ULNRC-2546

DOCKET NUMBER 50-483
CALLAWAY PLANT
RELAXED AXIAL OFFSET CONTROL

Union Electric Company herewith transmits an application for amendment to Facility Operating License No. NPF-30 for the Callaway Plant.

RELAXED AXIAL OFFSET CONTROL (RAOC)

AXIAL FLUX DIFFERENCE LIMITS AS A FUNCTION OF
RATED THERMAL POWER FOR RAOC

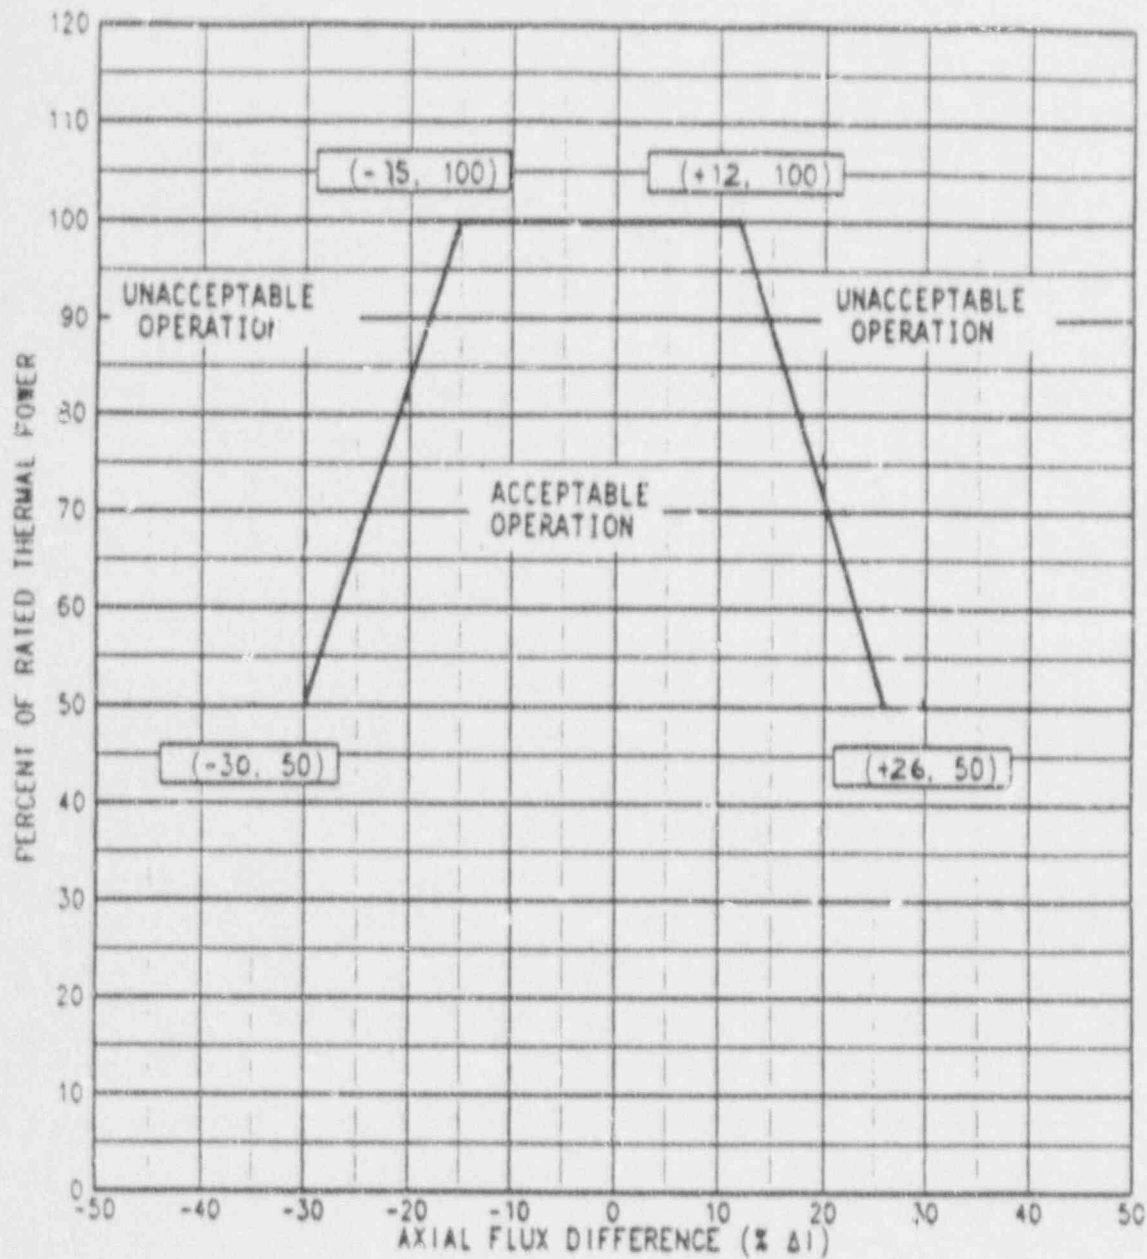
INSERT 2

2.4.1 The Axial Flux Difference (AFD) Limits are provided in Figure 3.

FIGURE 3

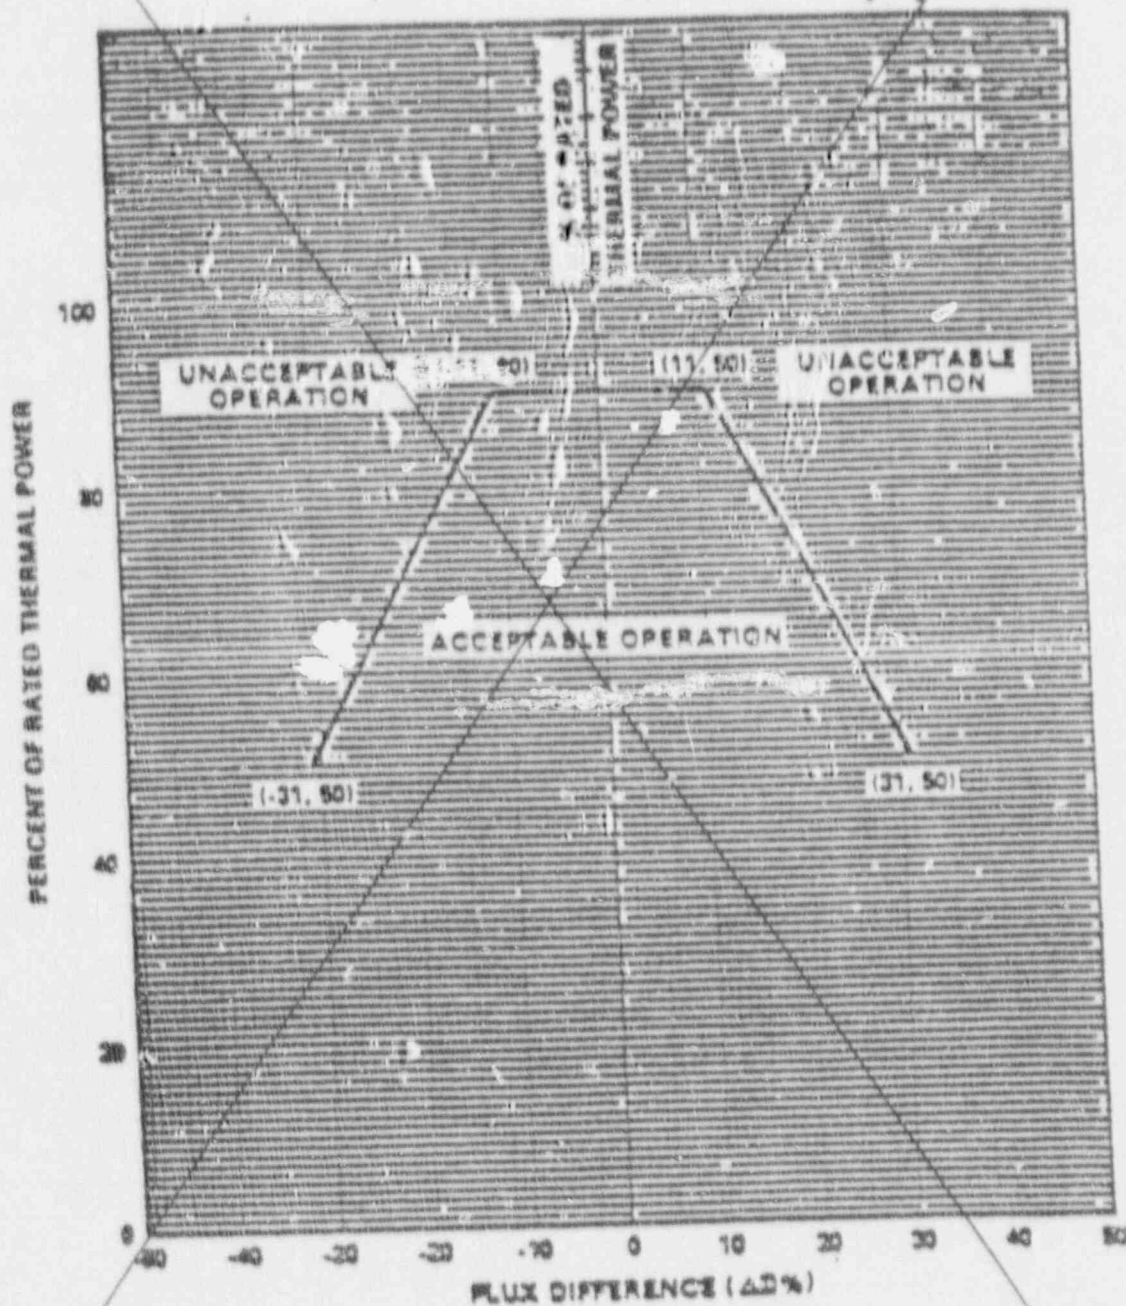
REPLACE WITH INSERT 2
